Review of “Watershed zonation approach for tractably quantifying above-and-belowground watershed heterogeneity and functions”

Author(s): Haruko M. Wainwright et al.

MS No.: hess-2021-228

L. Band, University of Virginia

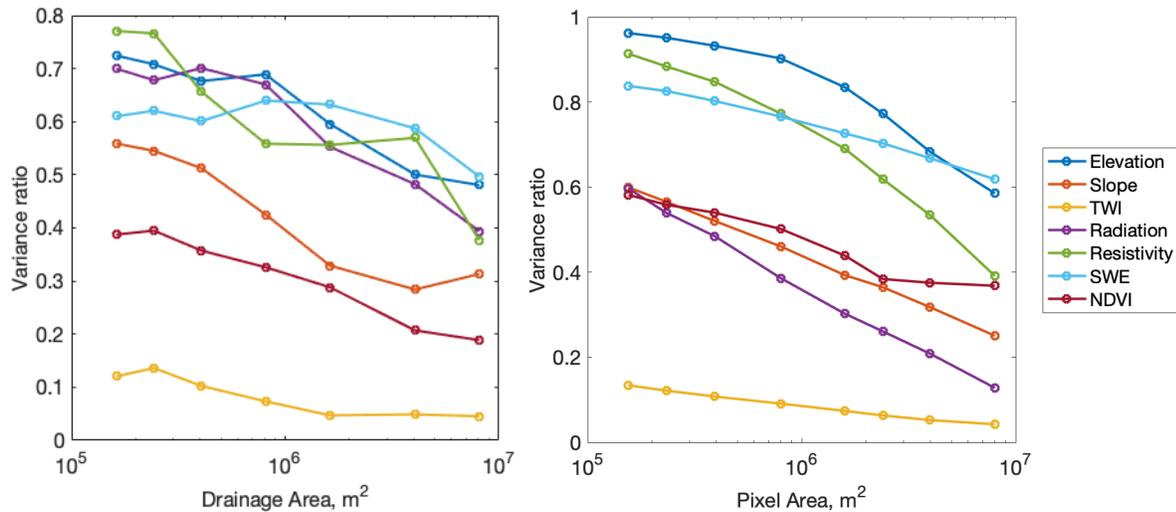
The paper investigates whether unsupervised clusters at the hillslope scale generated by three different approaches produce a coherent, organizing template for the multiple spatial variables, and can capture observable variance in two land surface and watershed and behaviors: drought sensitivity and nitrogen export. A single hillslope partition is generated as a template to form clusters, using mean values of the spatial data coverages, without considering within unit variance. More detail should be given to justify the scale of the hillslope partition, as larger or smaller hillslopes may yield different distributions of mean parameter values, and resulting clusters based on altered between and within unit variance. Additional information can be included in a table in the paper or supplement: number of hillslopes, characteristics (e.g. area, relief, etc). It would be useful to inspect the balance of between- and within-unit variance, to demonstrate how much of the total landscape variance is captured by the hillslope partition. The effects of variable hillslope sizes and numbers on the representation of watershed heterogeneity and impacts on coupled water and carbon cycling has previously been investigated in similar Rocky Mountain watersheds (e.g. Band et al., 1991, 1993; and others).

Given the high topographic relief, strong topoclimate gradients in radiation and water balance, and intercorrelation of a number of the spatial datasets used, it is likely that any partitioning of the landscape (hillslopes or grid cells) would produce a reasonable clustering and may have distinct association with specific landscape functions. The three hypotheses stated in the introduction could be strengthened if the concept of an optimal scale of hillslope partitioning was posed, or included the scale dependence of results. This may require multiple hillslope partitions (different extents of the stream network), and consideration of subhillslope scale variance – essentially generating multiple realizations of the methods used in the paper across scales.

Answer: Thank you for this great suggestion and these papers. We agree that different sets of hillslopes can be defined depending on the scale or the threshold flow accumulation (or drainage) area to define stream segments. In the original manuscript, we have set the threshold to match the observed streams. In the revised manuscript, following Band (1989) and Band et al (1991), we have generated different sets of hillslopes based on the flow accumulation threshold to define streams.

For the hillslope metrics that are defined by the average (e.g., average elevation, average slope), we evaluated the within-hillslope variability and across-hillslope variability of each property, compared to the overall variability. We consider that the variance of pixel-by-pixel properties represents the overall variability over this domain, while the variance of hillslope-averaged metrics represents the variability across the hillslopes. We computed the ratio between the across-hillslope variance and overall variance, representing how well the hillslope-averaged metrics can capture watershed-scale variability.

Figure X1 (below; Figure 2 in the manuscript) shows this ratio as a function of the threshold drainage area. The ratio is high for the elevation, radiation, snow, and bedrock resistivity up to 0.75, which means that the hillslope-averaged metrics

capture the watershed-scale variability of these variables and that the within-hillslope variability is small compared to the across-hillslope variability. TWI and NDVI, on the other hand, have a low ratio, which means that the within-hillslope variability is significant. The ratio increases as the drainage area decreases, since the smaller the hillslopes are, the better they capture the small-scale variability. However, the variance ratio of the elevation and radiation reaches a plateau with the drainage area around  $10^6 \text{m}^2$ . Based on this result, we selected  $810,000 \text{m}^2$  as the threshold drainage area in the subsequent analysis.

In addition, as a contrast, we included the variance of each property at the upscaled pixel (i.e., taking the averaged value in larger pixel sizes compared to the original 9-meter pixel) compared to the overall variance (Figure X1b). The ratio between the across-upscaled-pixel variance and the overall variance increases as the pixel size decreases. Different from the hillslope average, the ratio for radiation keeps increasing without reaching the plateau. This means that a representative size or scale of pixels does not exist when we use pixel-based upscaling.

We also considered the implication of this plateau. Hillslopes have been used as an organizational unit for watershed hydrology (Fan et al., 2019) as well as critical zone science (Brantley et al., 2019). In particular, Pelletier et al. (2019) showed a significant impact of hillslope aspects and slopes on evapotranspiration, weathering, nutrient cycling, and others. The plateau of the ratio between the across-hillslope and overall variance suggests that there is a representative hillslope scale for radiation (which is a function of slope and aspect), at which the hillslope average can capture the majority of the pixel-by-pixel variability at the watershed scale and the within-hillslope variability is small. At the same time, the ratio for NDVI (associated with plant dynamics) and TWI (associated with soil moisture) continues to increase as the hillslopes become smaller. This is due to the fact that they are significantly affected by microtopography and within-hillslope positions (i.e., toe slopes). These results suggest that we may define a hierarchical representation of spatial heterogeneity such that the watershed-scale variability of elevation and radiation is captured by hillslopes, while the other properties are defined within each hillslope.

We included these texts and Figure 2 in the manuscript (the third paragraph in Section 3.1 in the methodology section; Section 4.1 in the result section; the third paragraph in the discussion section)

Figure X2. Correlation and scatter plots (Pearson's correlation coefficients) among selected hillslope features (Table S1). The \* sign represents p-values < 0.01.

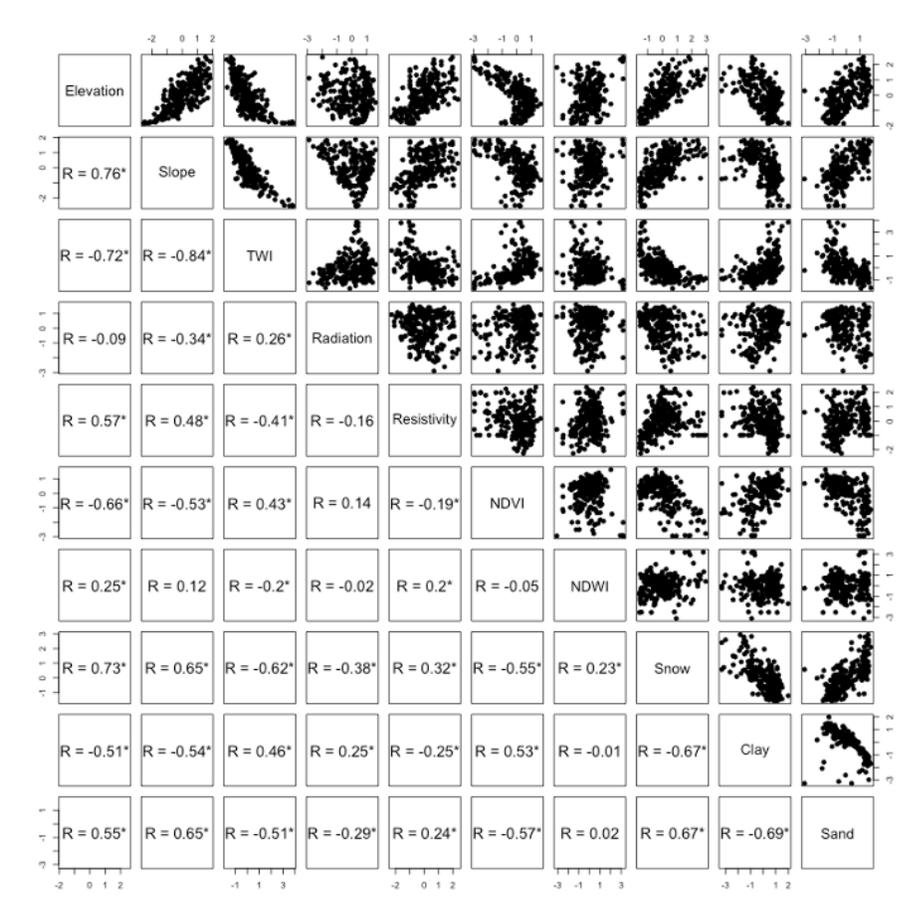
Soils are often the weak link in distributed watershed data, as discussed by the author. While bedrock geology is used instead of soils in this study, available soil data (SSURGO downloaded from the USDA web soil survey site) shows substantially more spatial detail than the bedrock maps. While SSURGO soils data important to water storage and flow are often highly generalized based on the mapping methods and cartographic presentation, there have been a number of methods published over the last decades to develop estimates of soil properties at resolutions comparable to available terrain information (e.g. Zhu et al, 1997), and more recently Chaney et al (2016, 2019) published a 30m soil property dataset for CONUS. The authors should better outline why soils, a central critical

zone component, were not used as part of the clustering. Similarly, while aspect was discussed in the paper as a central influence on critical zone behavior, it was not included. While potential radiation may explain much of the information aspect may convey, aspect is a simpler and more widely available measure (but needs to be treated as a circular variable or transformed into a linear surrogate, such as the widely used “southness”).

Answer: We have agreed with this comment, and included soil texture (%clay, and %sand) from Chaney et al (2016). Figure X2 (below; Figure 2 in the manuscript) shows that soil texture is correlated with the elevation, slope, and other metrics at the hillslope scale. We have updated the clustering results as well. Although the zones are slightly different from earlier results, the general observations (e.g., types of hillslopes, validation) are the same, since %sand and %clay are correlated with elevation and other metrics
